Subject: 228th Multifamily Development, Northpoint Apartments
1010—228th Street SW, Bothell, WA
PFN: 21-109327-LDA
PFN: 22-102098-SPA
PFN: 22-102093-PRO
Ecology Permit No.s: WA0991044 & WAG503168

Lider Engineering has reviewed the files associated with the subject project, received through August 2, 2022. It is my opinion that the 544 apartment units with 994 parking stalls proposed by NP Snohomish County 228th Apartments, LLC (Northpoint), a Delaware LLC, will have significant adverse impacts that are not mitigated by the currently submitted design documents; and that a Determination of Significance (DS) and an Environmental Impact Statement (EIS) is warranted.

Figure 2: Landau Groundwater Analytical Results for Arsenic Testing, December 9, 2021. The current water quality criteria for the protection of human health for total inorganic arsenic is 0.018 µg/L per the USEPA.

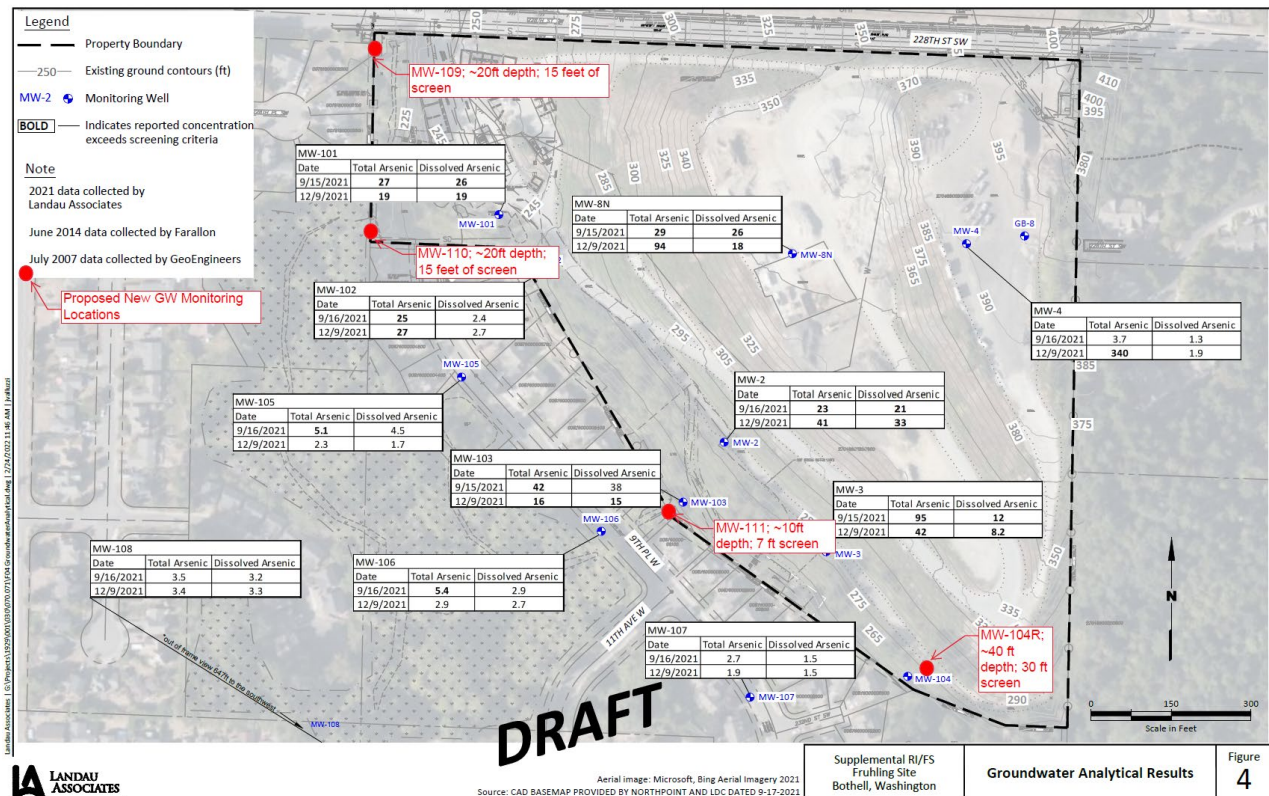
While Landau failed to report the units for total arsenic in the map above, it appears that all measurements exceed levels for the protection of human health required by the EPA.

Figure 3: Annotated clip from page 5, Plat of Eastglen showing 10-ft Private Drainage Easements (PDE). SNOCO does not have authority to permit Northpoint to use these PDE's for landscaping or any other use

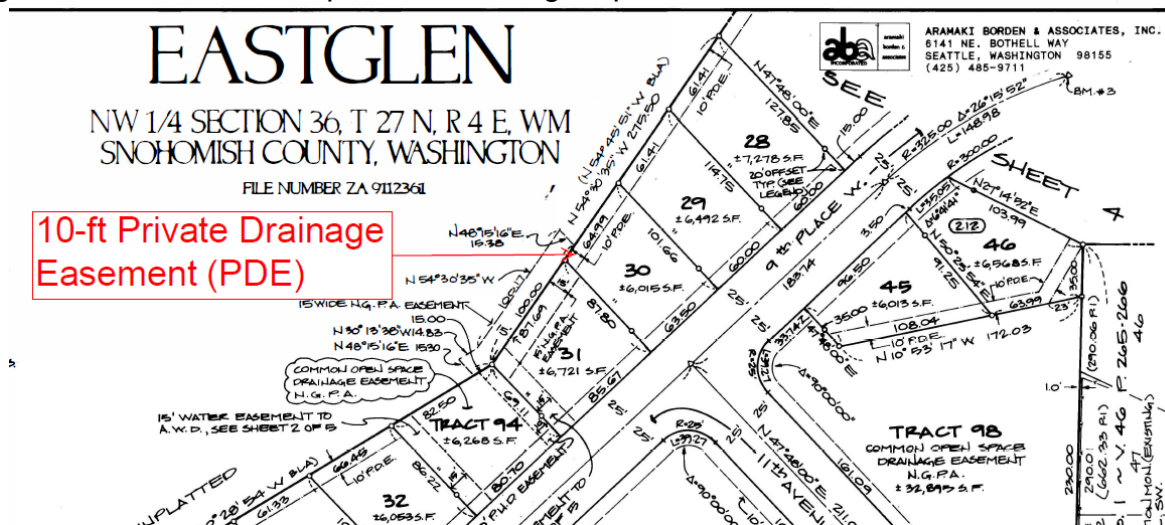
The Plat of Eastglen, page 5, designates a 10-foot wide private drainage easement on the easterly side of Lots 28-30; and a 15-foot wide NGPA on the easterly side of Lot 31. Private Drainage Easement requirements are prescribed under SCC 30.63A.595. The Eastglen plat does not automatically permit Snohomish County or Northpoint use or access to Private Drainage Easements, designated as PDE's on the Eastglen plat. It was unlawful for Snohomish County to grant Northpoint access or use of Eastglen private drainage easements, without written authorization from the Eastglen HOA and the property owners. Under public records request K073269, PDS confirmed that it did not have written authorization by the property owners and Eastglen HOA authorizing access to the private drainage easement because this information was not in the PDS project file.

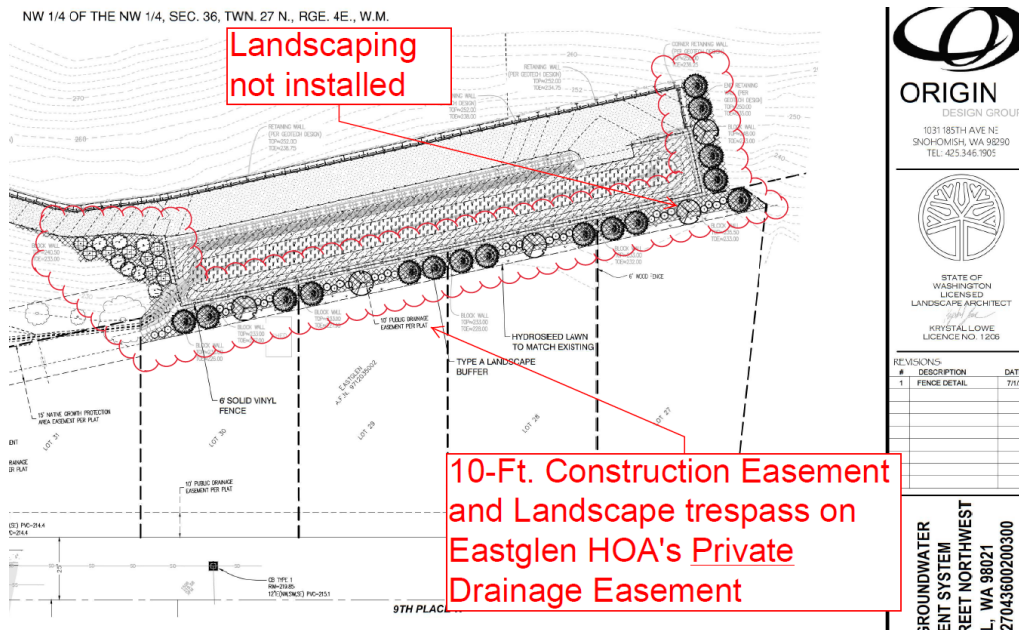
The MTCA bioretention swale design approved by Ken Crossman failed to identify that work was being permitted on land not owned by Fruhling or Northpoint; and to trespass on a 10-foot wide private drainage easement for construction access and to install a permanent Type A landscape buffer between the Eastglen homes and the MTCA groundwater treatment system without documentation of written authorization from the

Figure 5 below is an annotated clip from drawing L-2 approved by Ken Crossman on August 24 under PFN: 21-109327-LDA. 2021 permitting construction work in the Eastglen Private Drainage Easement, without authorization from the Eastglen HOA.

Figure 6: Annotated clip from Sheet GR-03, sealed January 7, 2022 showing the location of the groundwater remediation swale constructed in the stream buffer

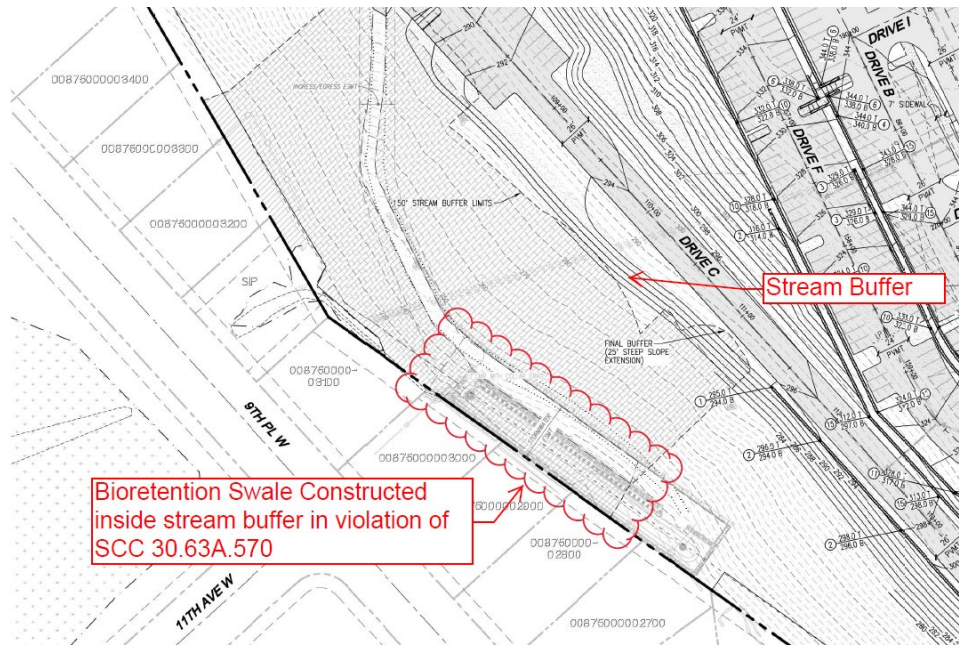
Northpoint did construct the MTCA groundwater treatment facility inside the stream/wetland buffer as shown Sheet GR-03, sealed January 7, 2022 by Thomas Abbott, as shown in the annotated clip, Figure 6 below. This is a significant, unmitigated impact that has resulted in piecemealing the impacts from the Northpoint Apartments that must be addressed in a comprehensive project EIS. WAC 197-11-262 requires Snohomish County to issue a determination of significance because the MTCA remediation swale was constructed in the stream buffer, with no mitigation.

Figure 7: Annotated clip from drawing RD-01, sealed by Thomas Abbott, PE, January 27, 2022 for the NP 228th Apartments project and currently under review by PDS for final approval.

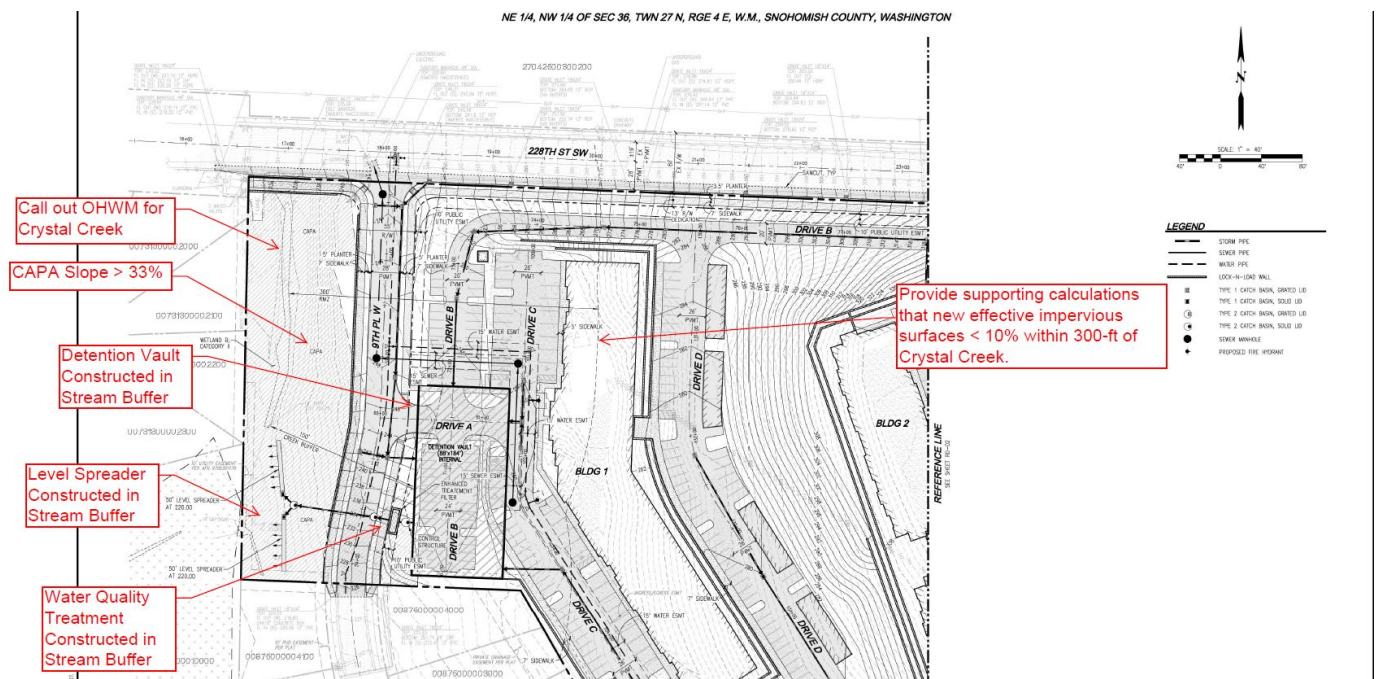
The current design proposal calls for 11th Place West to be extended through the Critical Area Protection Area (CAPA), and within the 150-foot stream buffer, shown in Figure 7 below. Road construction in the stream buffer and CAPA are not allowed. Furthermore, there is no buffer width averaging proposed, nor is buffer width averaging possible in this location.

- Water quality treatment and portions of the stormwater detention vault are constructed within the 150-foot stream buffer. This is explicitly forbidden under the County Code and 2021 *Drainage Manual*. These structures must be re-designed such that they are not in the stream buffer.

- It is proposed that 11th Ave be extended north to 228th Street SW through the wetland and Crystal Creek stream buffers and Critical Area Protection Area (CAPA). This intensive use is not permitted under County Code in the 150-foot Type F stream buffer. No mitigation is proposed and this will create harm to federally listed threatened Chinook and other salmonid species reported in Crystal Creek.

- SCC 30.62A.320(1)(b)(ii) requires buffer widths on slopes 33 percent or greater to be extended an additional 25-feet beyond the standard buffer widths specified in SCC 20.62A. It appears that the CAPA slopes exceed the 33 percent minimum, and an additional 25-feet is required beyond the standard buffer widths.

Here, Northpoint proposes to use a level spreader in a permanent stormwater application. Simply put, level spreaders quickly fail over time and are not reliable or maintainable to disperse stormwater flows. Stormwater will quickly concentrate in the path of least resistance and form a gully into Crystal Creek. Level spreaders are not permitted by Snohomish County for this type of stormwater dispersion.

Figure 9 Annotated clip drawing URDS-01, sealed by Thomas Abbott, July 15, 2022 and currently under review by PDS. It can be anticipated that there will be a major traffic increase through the Eastglen neighborhood.

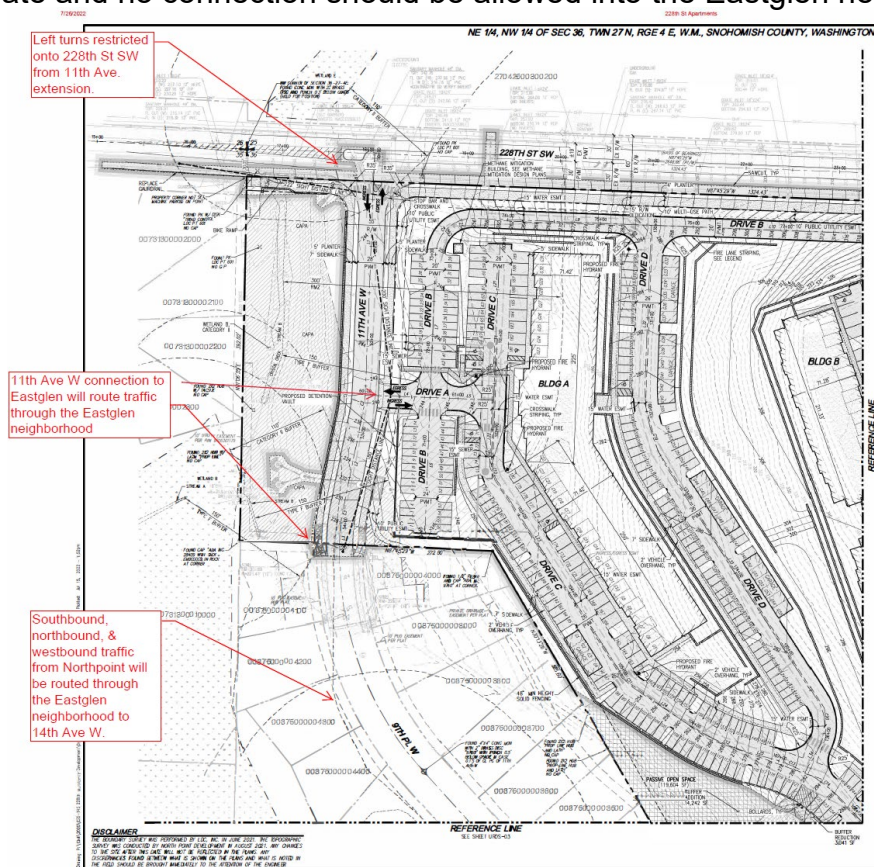
No traffic distribution analysis was provided as required by SCC 30.63B.035(5). Because no left turns will be permitted at lower 9th Avenue and 228th Street SW intersection, it can be anticipated that almost all north, south, and west bound traffic will use residential streets through the Eastglen neighborhood to access 14th Avenue W. Increased accidents can be anticipated as result of Northpoint residents speeding through neighbor either going or returning from work. These low volume residential streets shown if Figure 9 below are unsuited for the heavy traffic that Northpoint will generate and no connection should be allowed into the Eastglen neighborhood.

Figure 10: Annotated SNOCO Drainage Inventory Map showing the location of two existing Fruhling outfalls, suspected underground piping, and possible stream diversion that must be investigated as a part of an EIS.

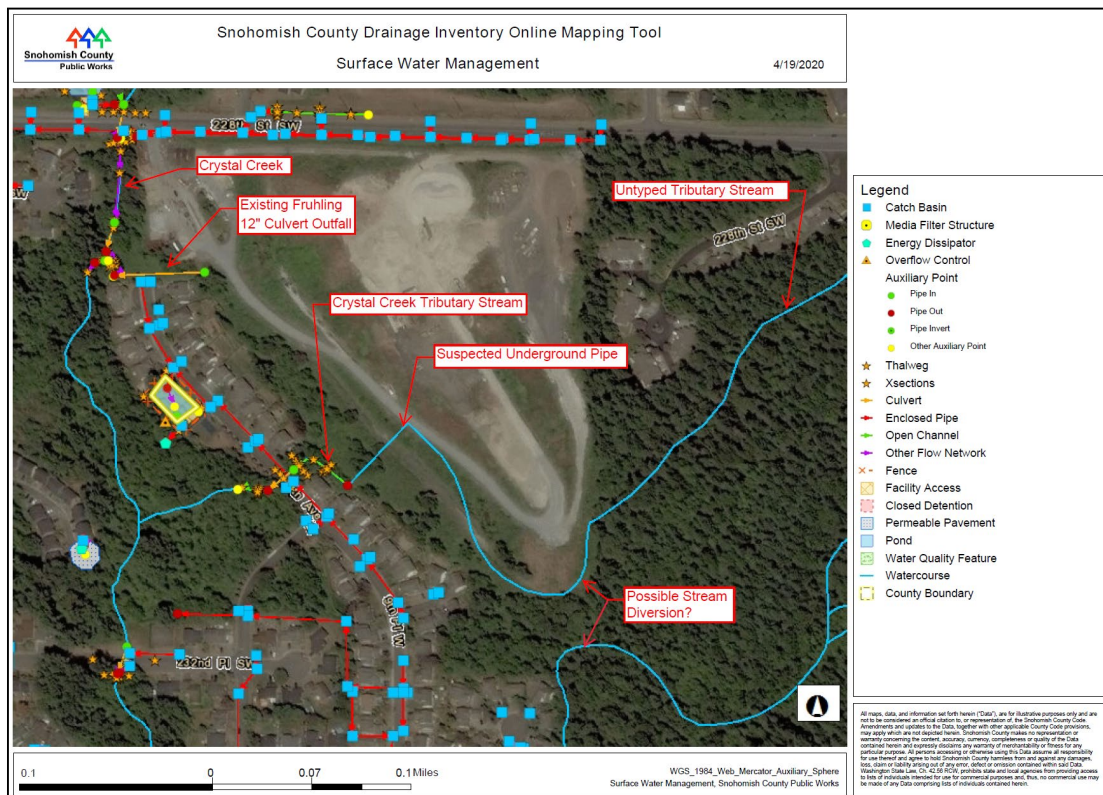
Snohomish County's Drainage Inventory Online Mapping tool shows an untyped stream flowing from the FEMA Regional Center property to the east and joining the Crystal Creek tributary stream at the eastside of the Northpoint property. It appears that Fruhling's gravel mining and landfill operations may have diverted the untyped FEMA Center stream from the Crystal Creek tributary stream possibly draining to the south basin to the south or routing the flow in a suspected underground pipe as shown in Figure 10 below:
